Up date of CD Players A725

2.1. Motor not starting when player is hot

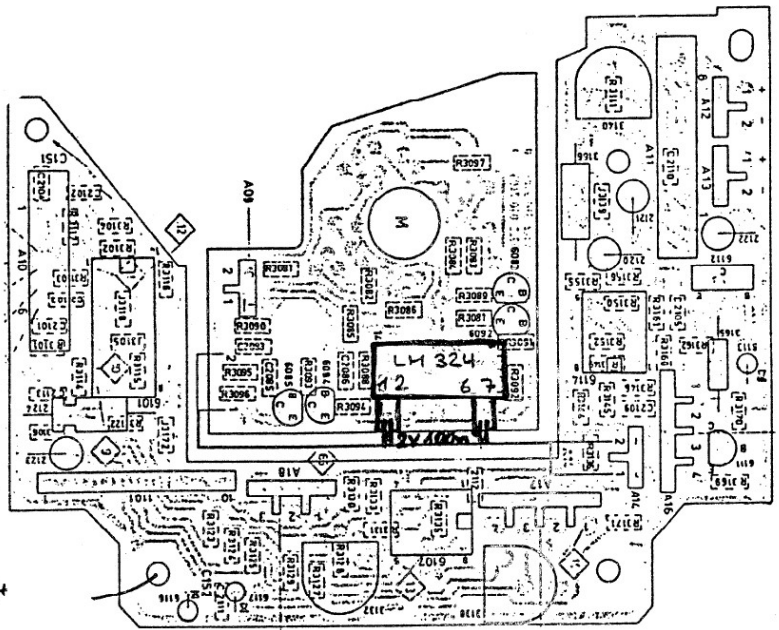
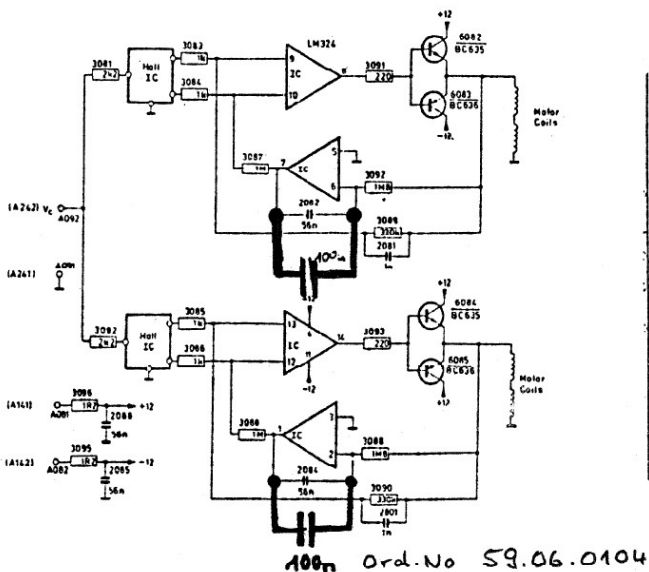
- Remove disc drive unit from CD-Player A725 (see Service instructions B225/A725 Section 2/1).
- Solder two 100 nF capacitors directly over pin 1 and 2 resp. 6 and 7 of IC LM 324 on disc drive pcb (see layout and schematic diagram above).
- Mount disc drive unit again

2.2. HIGH TEMPERATURE FAILURES OF A725

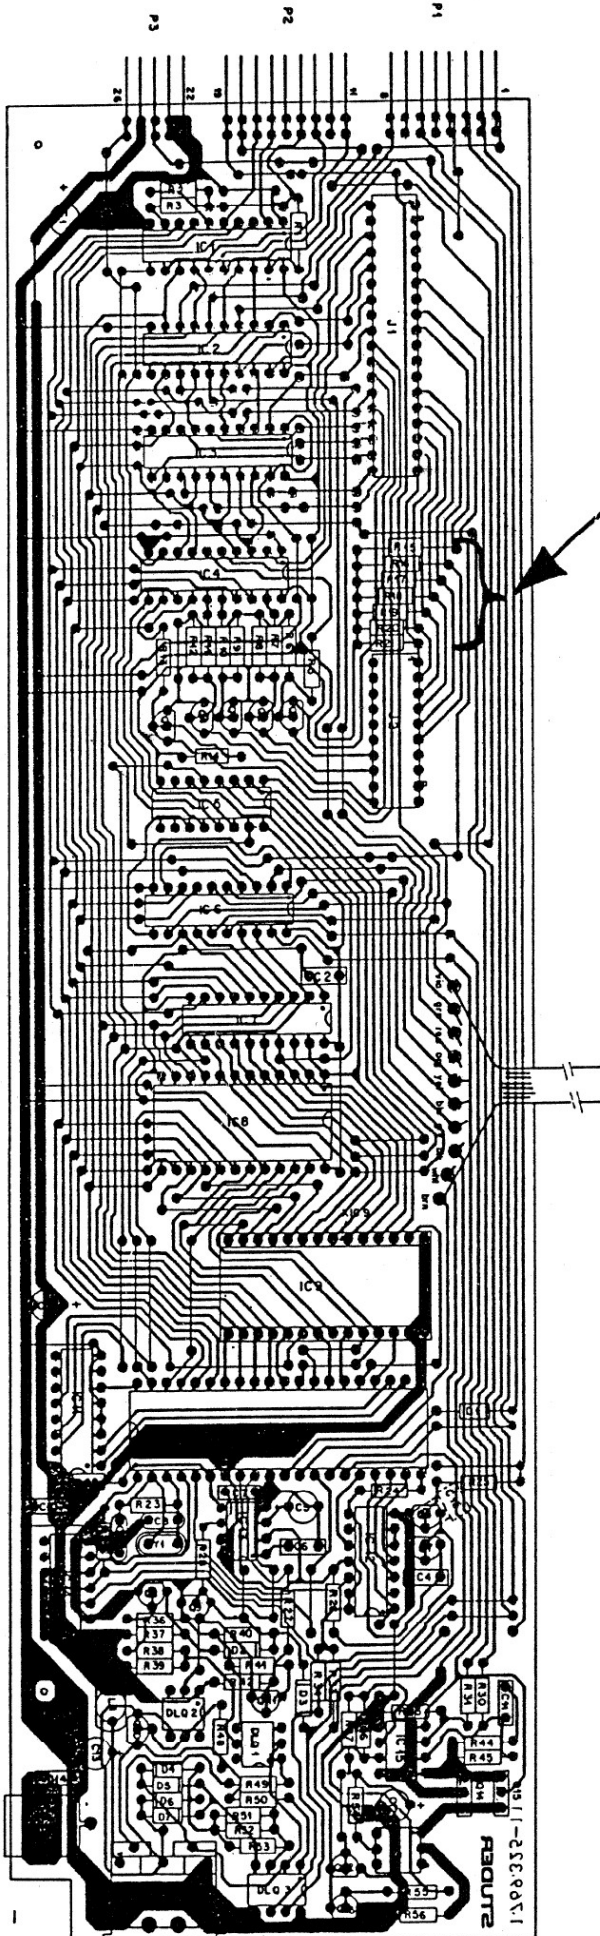
If CD-Players A725 happen to break down at high environment temperatures (above 40° C) in the way that they don't accept commands or reverse functions of push-buttons, you can replace the subsequently described 7 pull up resistors on μP pcb 1.769.325 by 820 ohm types instead of 4k7 types.

7x 820 Ω Ord. No: 57.11.4821
